Re: Niagara Mohawk Power Corporation  
Nine Mile Point Nuclear Station Unit No. 1  
Docket No. 50-220

APPLICATION FOR AMENDMENT  
TO  
OPERATING LICENSE

Proposed Change to Technical Specifications

Nine Mile Point Unit 1 Nuclear Power Station  
Rod Withdrawal Error Transient Analysis

Figure 1. NMP-1 Cycle 3 Notch Position of Transient Rod versus ΔMCPR for 7x7 Fuel

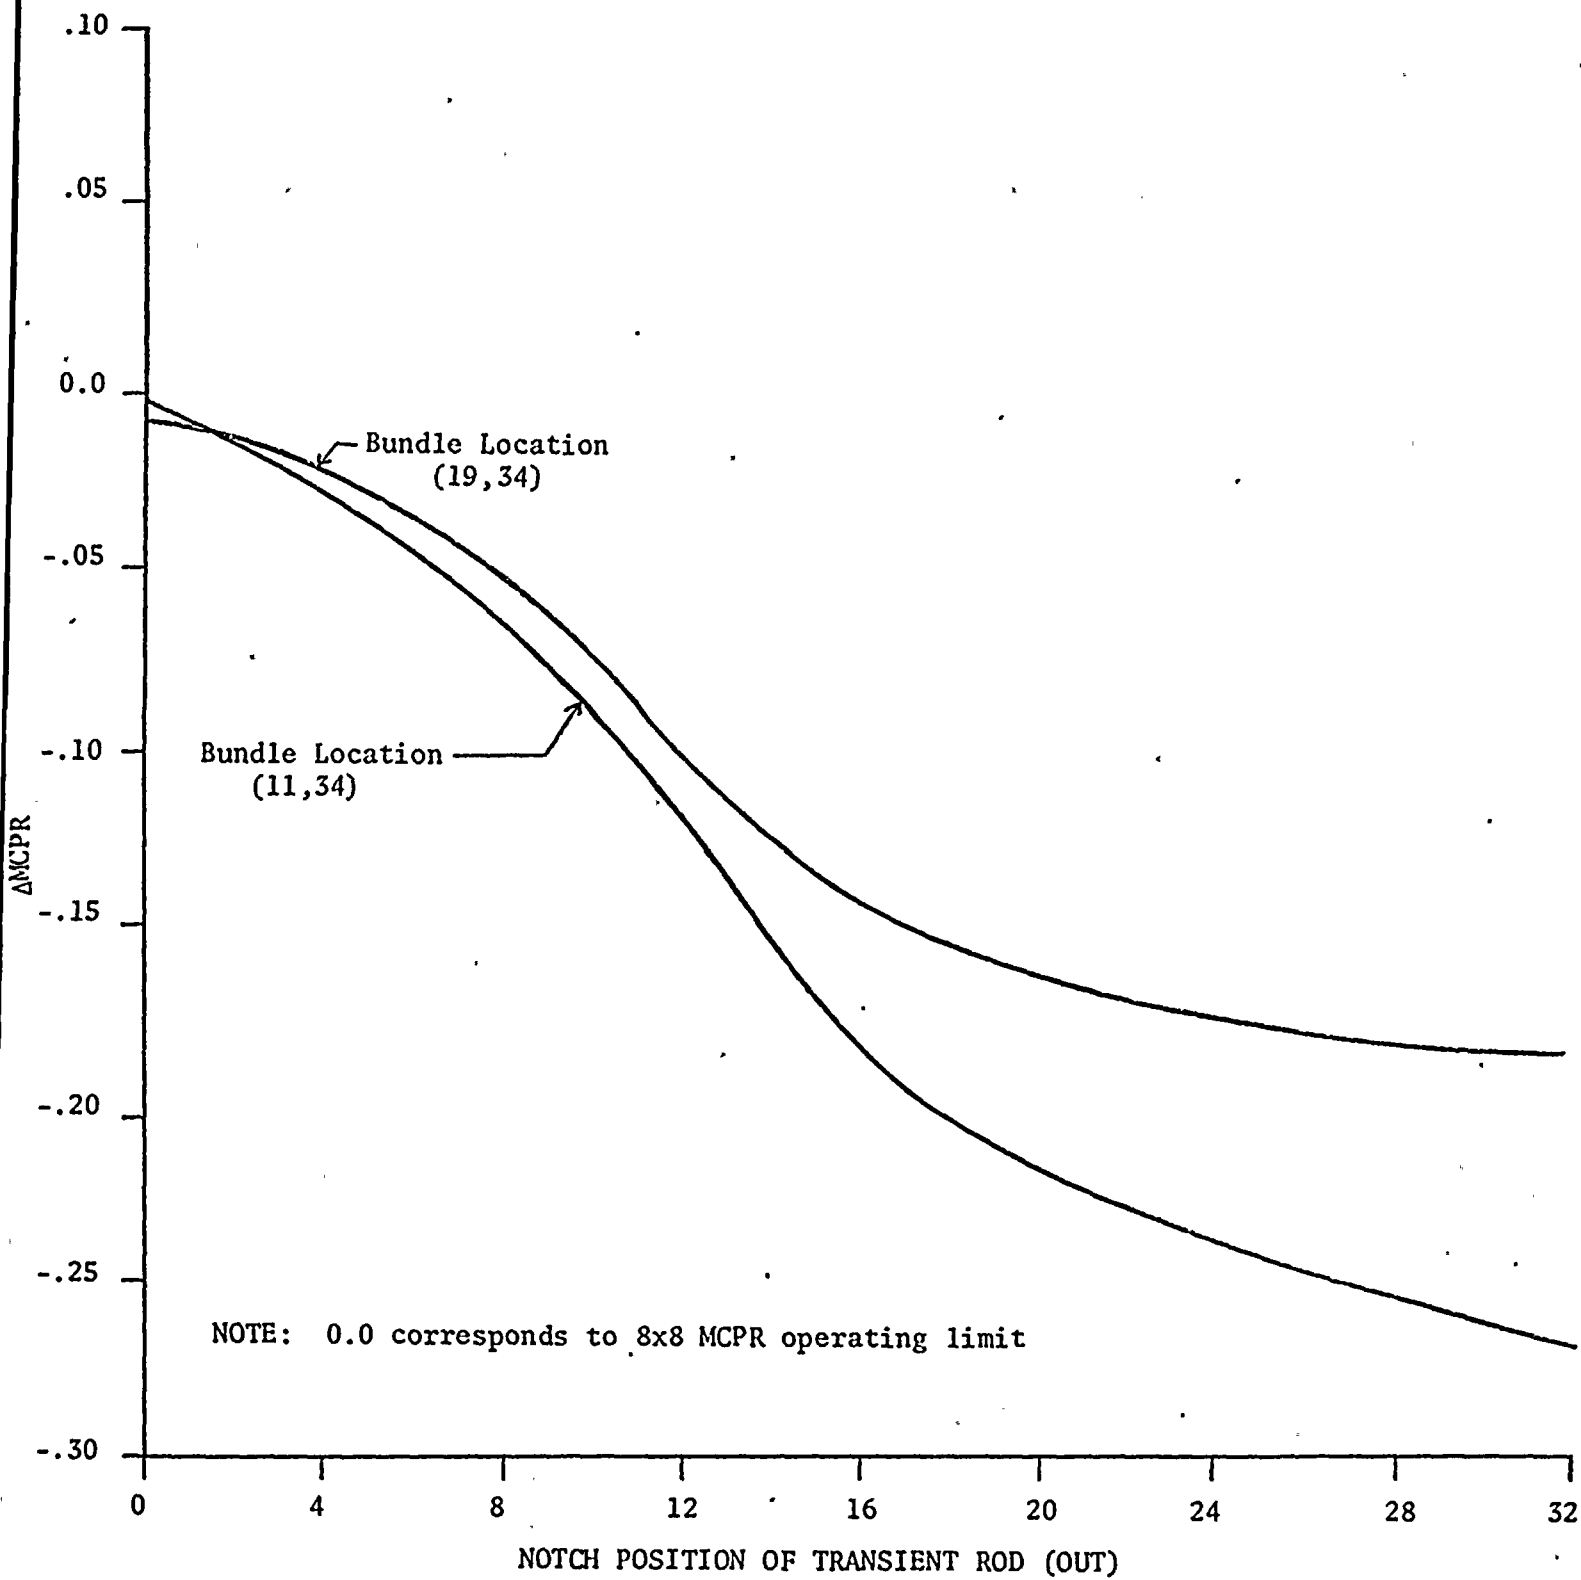
With the rod block setting at 105%, the Cycle 3 rod block response is shown in Figures 24 and 25 of Reference 4. The worst case MCPR at rod block is determined from the attached Figures 1 and 2.

Figure 2. NMP-1 Cycle 3 Notch Position of Transient Rod versus  $\Delta MCPR$  for 8x8 Fuel

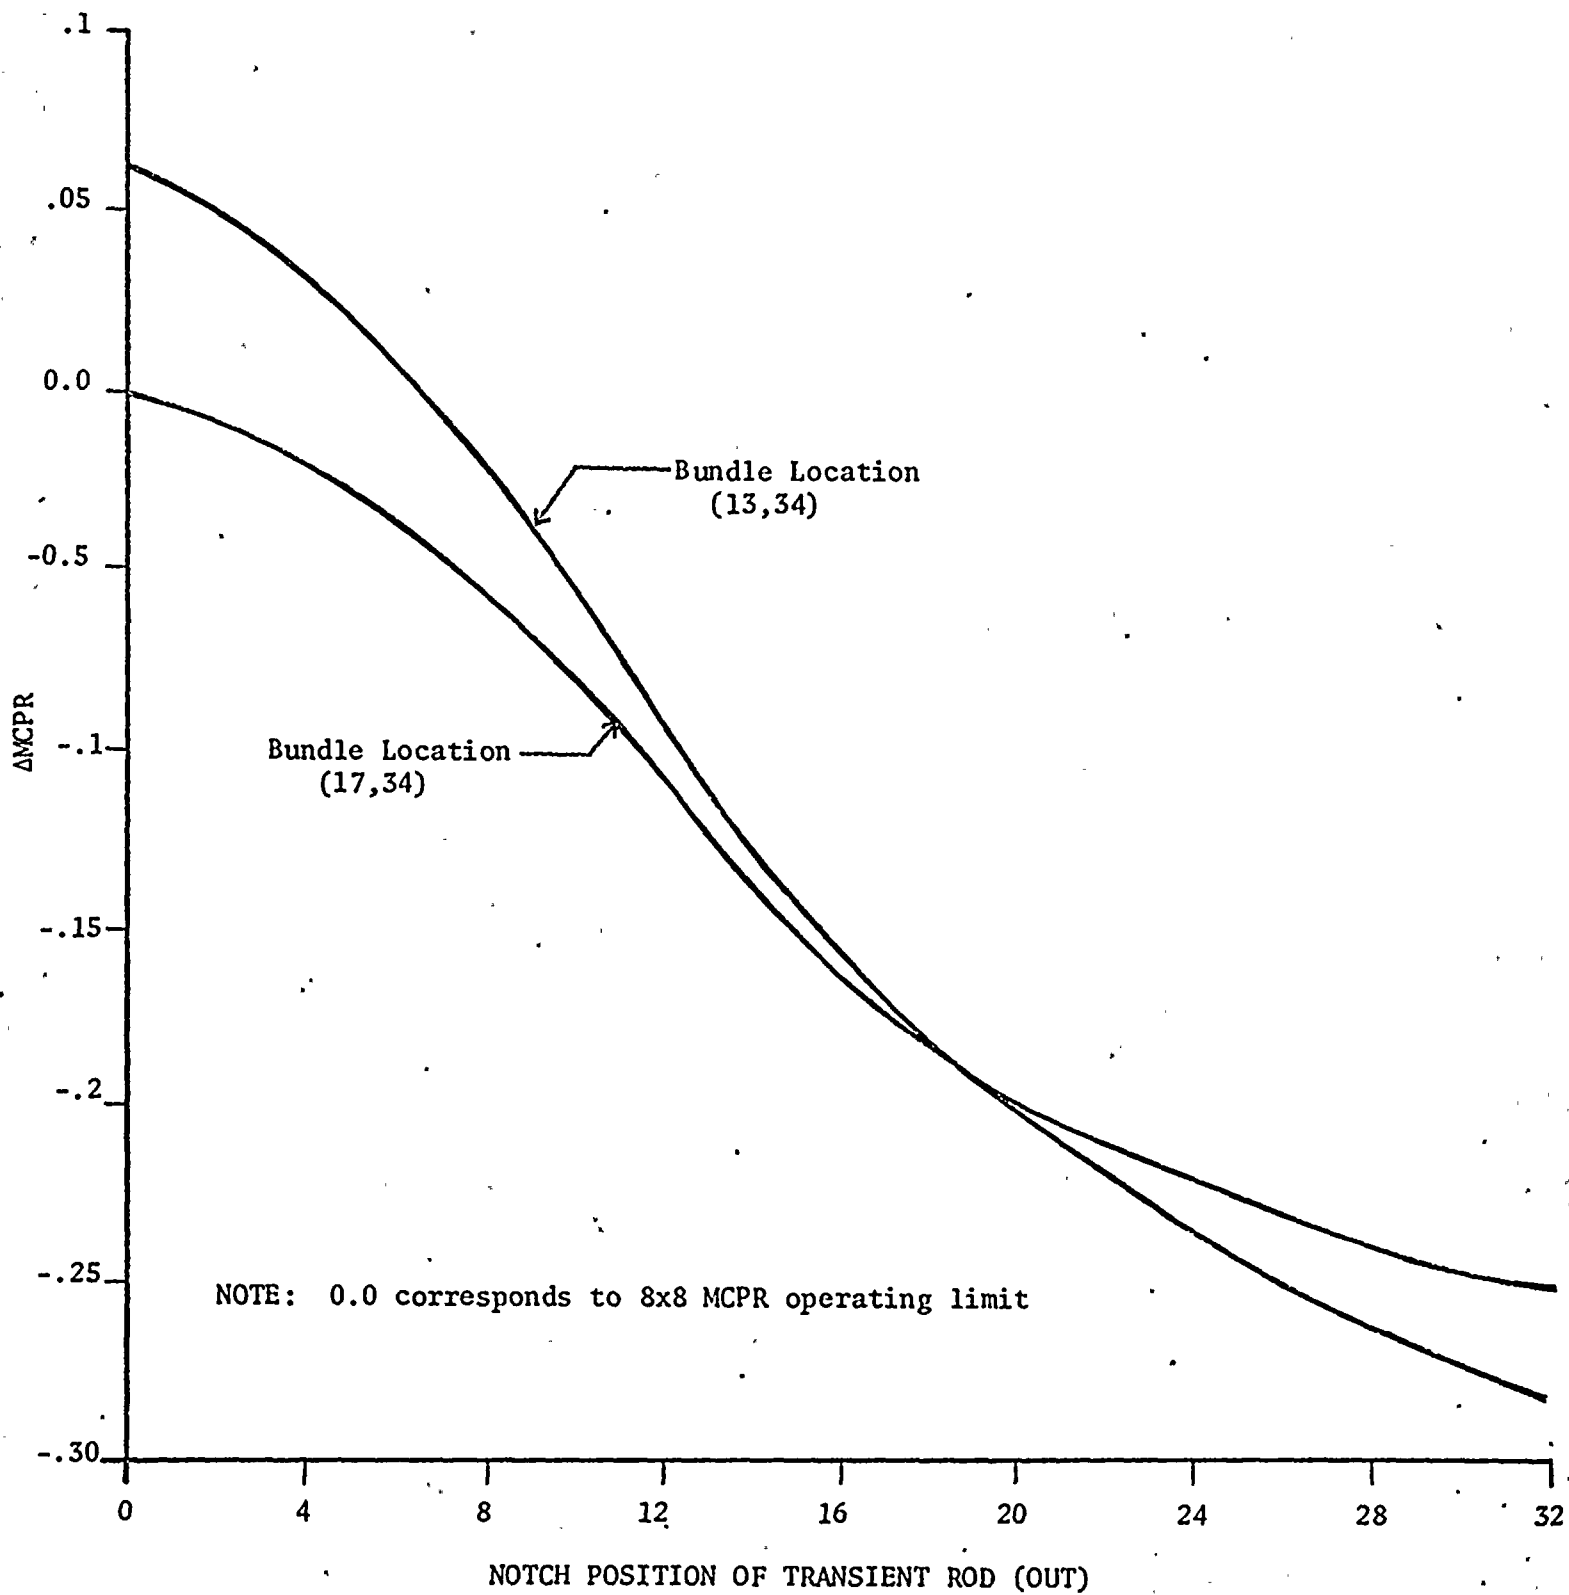
As a result of this analysis, it is necessary that the 8 x 8 MCPR operating limit be increased to 1.25, in order to avoid violating the MCPR Safety Limit during a postulated rod withdrawal error transient.

<u>Item</u>	<u>Location*</u>	<u>Change</u>
Limiting Condition for Operation 3.1.7c	Page 64a	Change Minimum Critical Power Ratio (MCPR) value for 8 x 8 fuel to " <u>≥</u> 1.25"
